**STAFF REPORT
ADDENDUM**

**CASE NUMBER: P.D. 07-344 CC L.U.C.B. MEETING: February 14, 2008
January 10, 2007**

DEVELOPMENT NAME: Shelby Park East Planned Development

OUTLINE PLAN PD 07-344 CC
SHELBY PARK EAST PD
 OWNERS: TERANSKY LLC, DIGGS FAMILY PARTNERSHIP
 DEVELOPER: TERANSKY LLC
 48 LOTS 13.557 ACRES

REVISED SITE PLAN

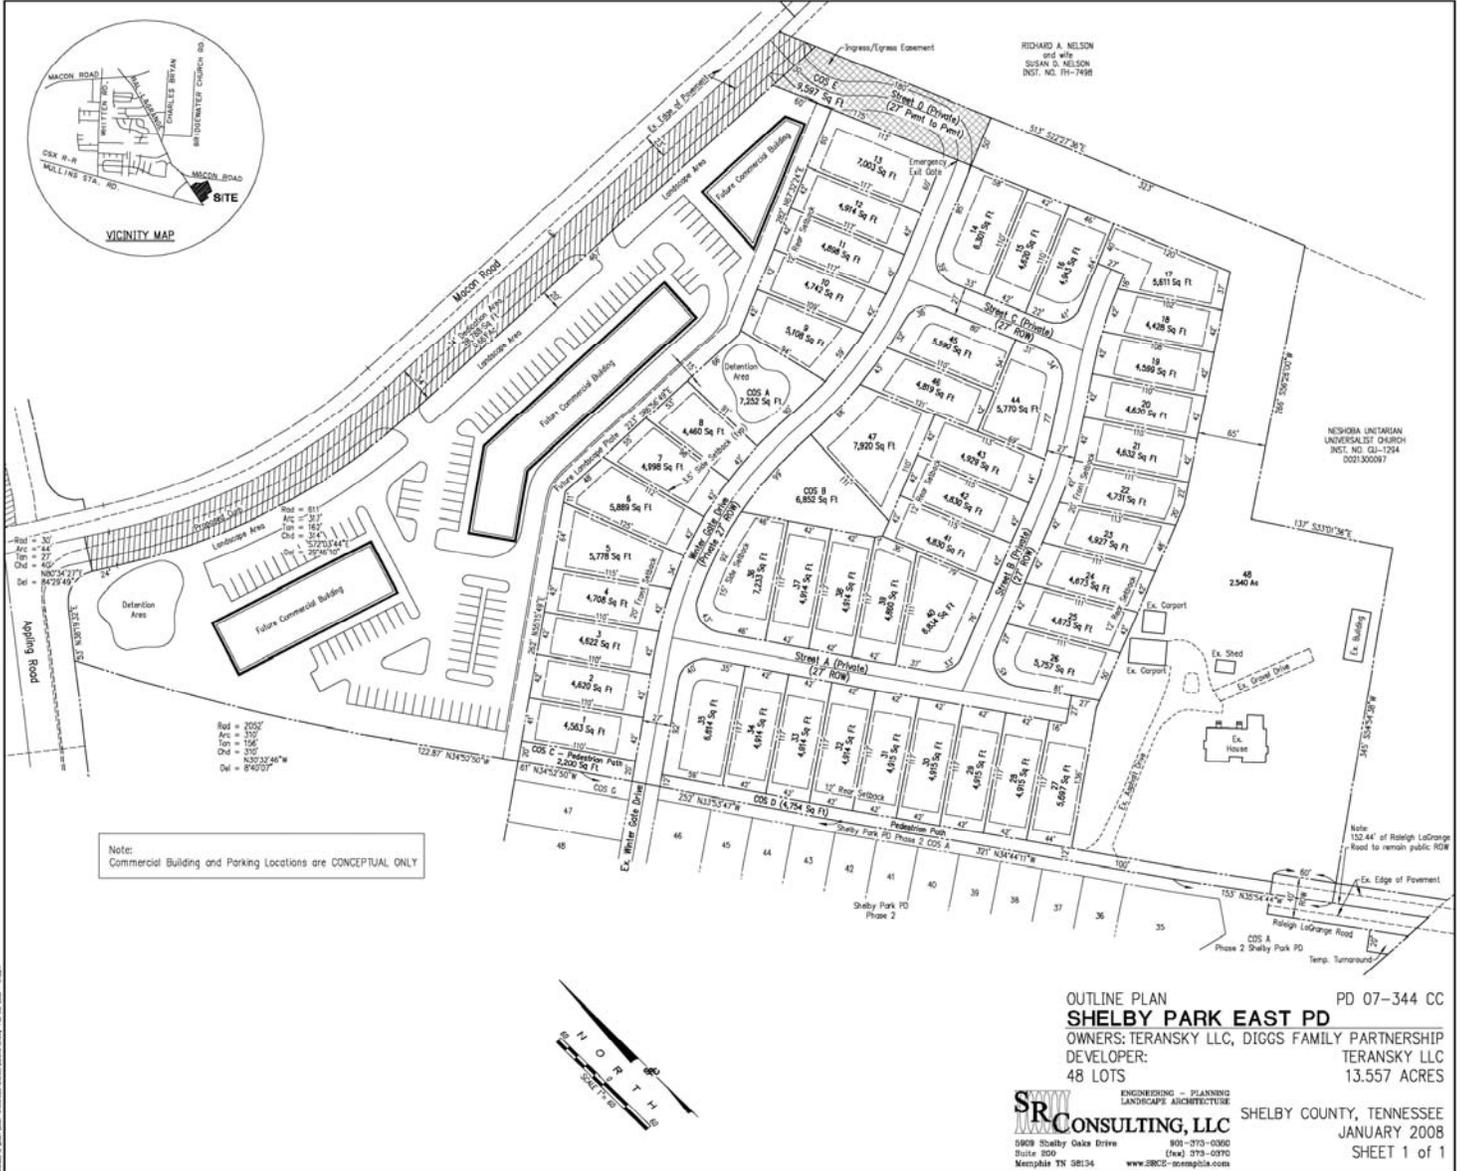
This planned development case was held at the January, 2008 Land Use Control Board meeting to allow the applicant additional time to address some of staff's concerns that still remain about the newly proposed site plan. The revised site plan reflects most of the recommended changes except two; the proposed use of private drives throughout the development and the proposed location of a required detention area in Area B separate from Area A as recommended by the County Engineering Office.

The first issue and of primary important is the proposed use of private drives within this small lot development. The private drives within this development are not desirable because of a couple of important reasons. First, small lots on private drives will not have sidewalks for safe pedestrian access. Public roads which requires the installation of sidewalks are needed to ensure safe and efficient circulation of both pedestrian and vehicle traffic between the residential and commercial areas of this development and the surrounding vicinity. Private drives as proposed in this development are not acceptable to adequately provide this function for its residents.

Secondly, the internal road system should be designed to include a consistent and pleasing streetscape along both sides of the road that will add to the overall appearance of this development's public realm. This is especially true given the lack of open green space along the frontages of small lot developments with a narrow road system. Twenty-seven (27) foot wide street widths are proposed throughout this development with a 20 foot front yard setbacks on each lot and no sidewalks. This type of design will not encourage or promote this development as a walkable neighborhood.

There are two options recommended to the resolve this issue. First, the applicant could change the private drives to public streets that would be dedicated and improved to public standards which include the provisions of sidewalks and planting green streetscapes. Secondly, the applicant could keep the private drives and build them to public standards which would include sidewalks and a tree lined green strip along both sides of the roads throughout this development. This option would provide for a 48 foot wide ROW that would include 28 feet of pavement from back of curb to back of curb, a 4 foot wide sidewalk, and a 6 foot wide tree green, exclusive of the 20 foot front yard setback on each lot (27 foot front yard setback for front facing garages). Either of these two options would aid in creating a desirable outdoor space for the residents of this new community.

One last and important point concerning the design and layout of this site plan. The site plan shows that the closest access to Macon Road is via an emergency exit only gate along the eastern side of the development. Macon Road is where the commercial/retail uses will be located within this development. Residents that wish to make a short trip to this area are expected to walk along private roads with no sidewalks to a pedestrian path that is provided at only one point in this development, along the western site boundary. Those that can't walk or do not wish to walk for whatever reason will be required to drive approximately 435 feet eastwardly to access the intersection of Appling and Macon Roads. Once at this intersection the residents will have to backtrack eastwardly to access the commercial center that will be adjacent to the north side of this residential community. A more convenient vehicle route and a second pedestrian path should be provided within this development to allow easier access to this commercial area.

A last item of concern pertains to the lack of a proposed detention stormwater areas in Area B that is separate from Area A as recommended by County Engineering. There is still no information or details concerning a proposed detention area in Area B on the site plan for consideration and early review by the appropriate governmental department. The County Engineering Office indicates that the placement of separate detention areas in both the residential and commercial portions of this development is very important and should be shown on the site plan. Staff agrees with the County Engineering that this information is needed on this conceptual site plan.

There is one additional item that should be pointed out for correction by the applicant. The site plan shows the proposed southern property lines to be closer than 5 feet to the existing carports that are located on proposed Lot 48. The Section 27. D.1.a. of the Zoning Ordinance requires that detached accessory structures (carports) be located not less than 5 feet from any side or rear lot line. The site plan should be revised to show this required setback for the existing accessory structures on Lot 48.
